**Project/File: Benari Estates/ EPP21-0021/ PPUD-07-21, RZ-12-21**

This is a preliminary plat, planned unit development, and rezone application to rezone a parcel from A to R-4 to allow for the development 133 single-family residential lots and 15 common lots on 35.29 acres.

Lead Agency: City of Eagle**Site address:** 1770 W. State Street**Staff Approval:** September 27, 2021

SITE PLAN

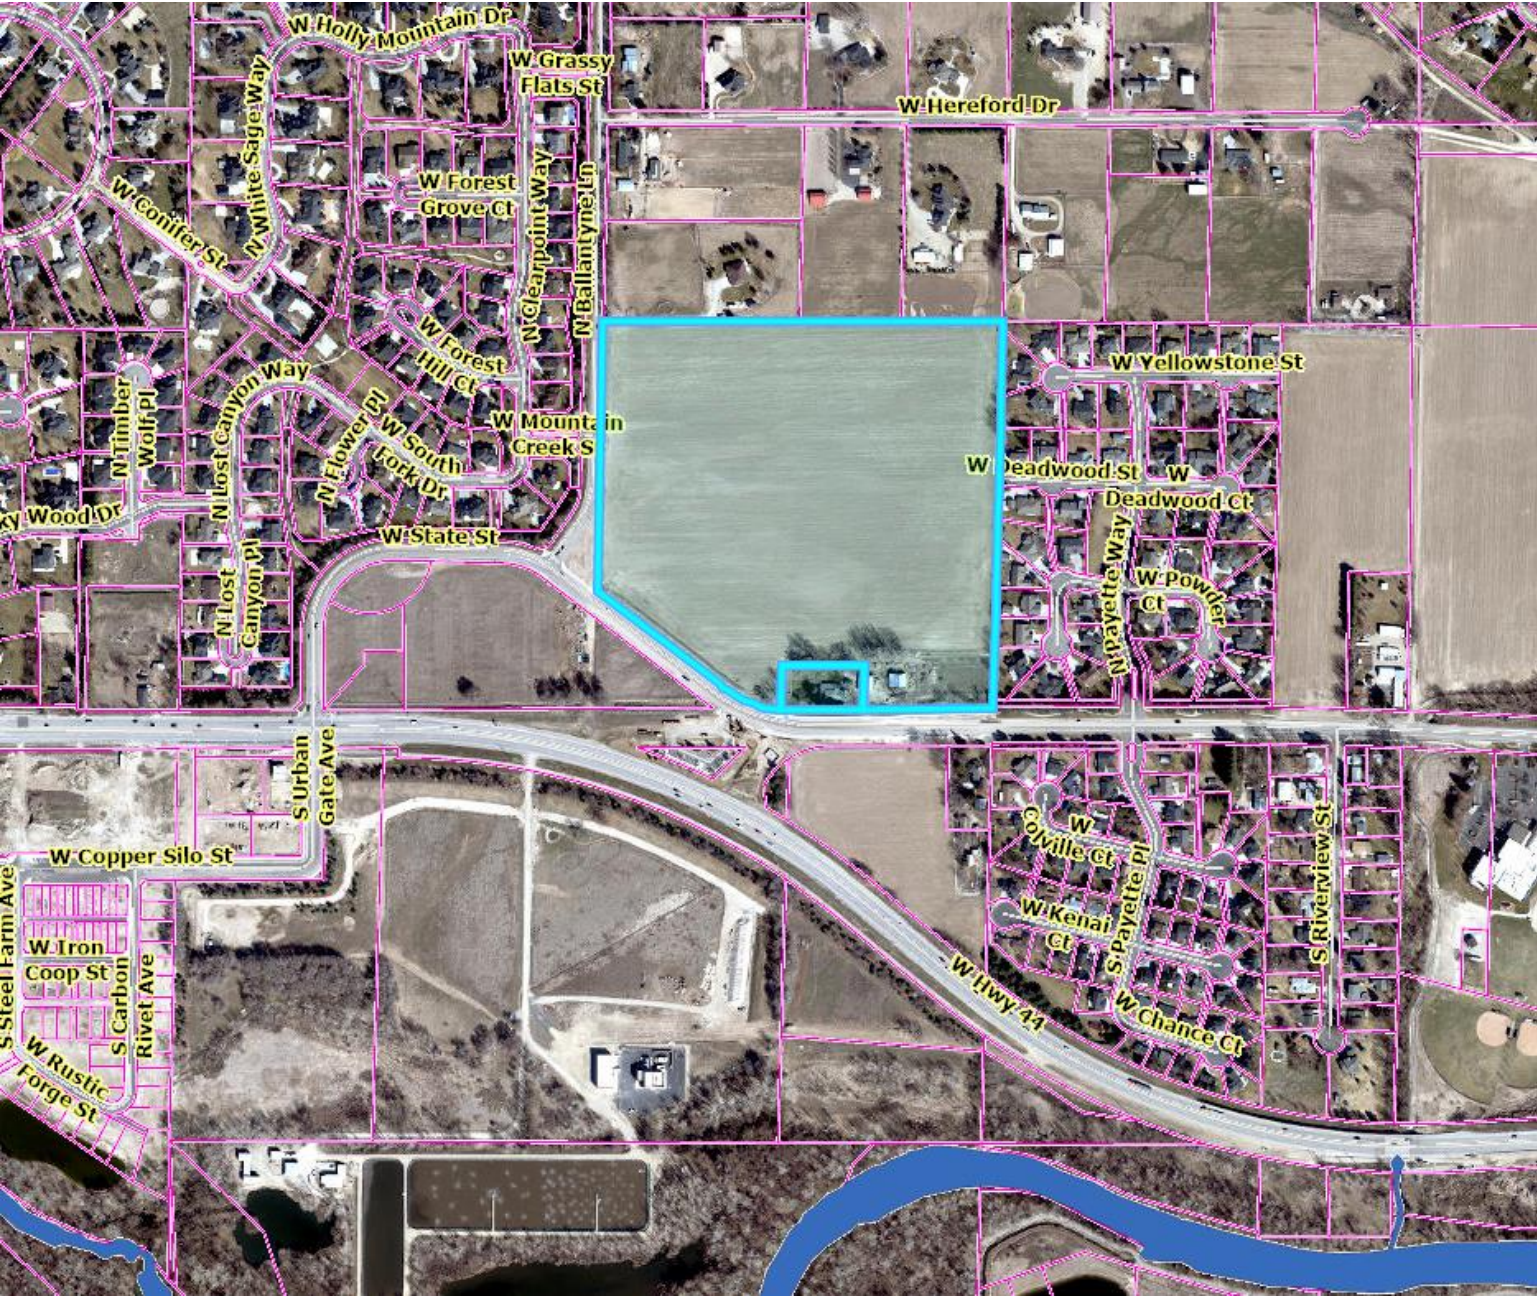
- d. **Staff Comments/Recommendations:** The applicant's proposal to improve Ballantyne Lane as a ½ a 35-foot rural collector street section does not meet District policy and should not be approved, as proposed. The applicant should be required to construct Ballantyne Lane has half of a 36-foot wide collector roadway with vertical curb, gutter, and 7-foot wide attached or 5-foot wide detached concrete sidewalk abutting the site. The applicant should dedicate additional right-of-way to extend 2-feet behind the back of curb for detached sidewalks and 2-feet behind the back of sidewalk for attached sidewalks. A permanent right-of-way easement should be provided for detached sidewalks located outside of the dedicated right-of-way.

- d. **Staff Comments/Recommendations:** The applicant's proposal meets District policy and should be approved, as proposed.

The applicant should be required to plat all of the center landscape islands as right-of-way owned by ACHD. The applicant or the future homeowner's association should enter into a license agreement with ACHD for any landscaping proposed within the islands.

A minimum 29-foot street section should be constructed around the center island proposed within the cul-de-sac at the terminus of Yellowstone Court. Parking within the island is prohibited.

Consistent with the recommendations of the traffic impact study, the application should be required to construct a bulb-out with a minimum of 24-feet measured face to curb to face of curb at the Yellowstone Street/Arrow Rock intersection.

- d. **Staff Comments/Recommendations:** If the City of Eagle approves the private roads, the applicant shall be required to pave the private roadway its full width and at least 30-feet into the site beyond the edge of pavement of all public streets and install pavement tapers with 15-foot curb radii abutting the existing roadway edge. If private roads are not approved by the City of Eagle, the applicant will be required to revise and resubmit the preliminary plat to provide public standard local streets in these locations.

The gated entry points on Powder Lane and Great Falls Lane should be located a minimum of 50-feet from the near edge of Forest Hill Drive and Deadwood Street and a turnaround should be provided.

3. Construct Ballantyne Lane as ½ a 36-foot collector street section with curb, gutter, and 8-foot wide planter strip and 5-foot wide detached concrete sidewalk. Dedicate additional right-of-way to extend 2-feet behind the back of curb and provide a permanent right-of-way easement for detached sidewalk located outside of the dedicated right-of-way.

4. Construct a center turn lane on Ballantyne Lane at Forest Hill (Mountain Creek) when Forest Hill is constructed to intersect Ballantyne Lane.
5. Close the existing driveway from the site onto Ballantyne Lane with curb, gutter, an 8-foot wide planter strip, and 5-foot wide detached concrete sidewalk, as proposed.

7. Extend Deadwood Street into the site and construct the internal local public streets (Forest Hill, Wood Stream, Yellowstone, Arrow Rock, and Great Falls) as 33-foot wide local street sections with curb, gutter, an 8-foot wide planter strip, and 5-foot wide attached concrete sidewalks. The dedicated right-of-way shall extend to 2-feet behind the back of curb and a permanent right-of-way easement shall be provided for detached sidewalk located outside of the dedicated right-of-way.

8. Construct a cul-de-sac turnaround with a center landscape island at the terminus of with an island Yellow Court, as proposed. Provide a minimum 29-foot street section around the center island and a minimum radius of 50-feet. Parking within the island is prohibited.

9. Provide written fire department approval for use of the reduced street section, specifically pertaining to the center landscape island in the cul-de-sac at the terminus of Yellow Court on site.
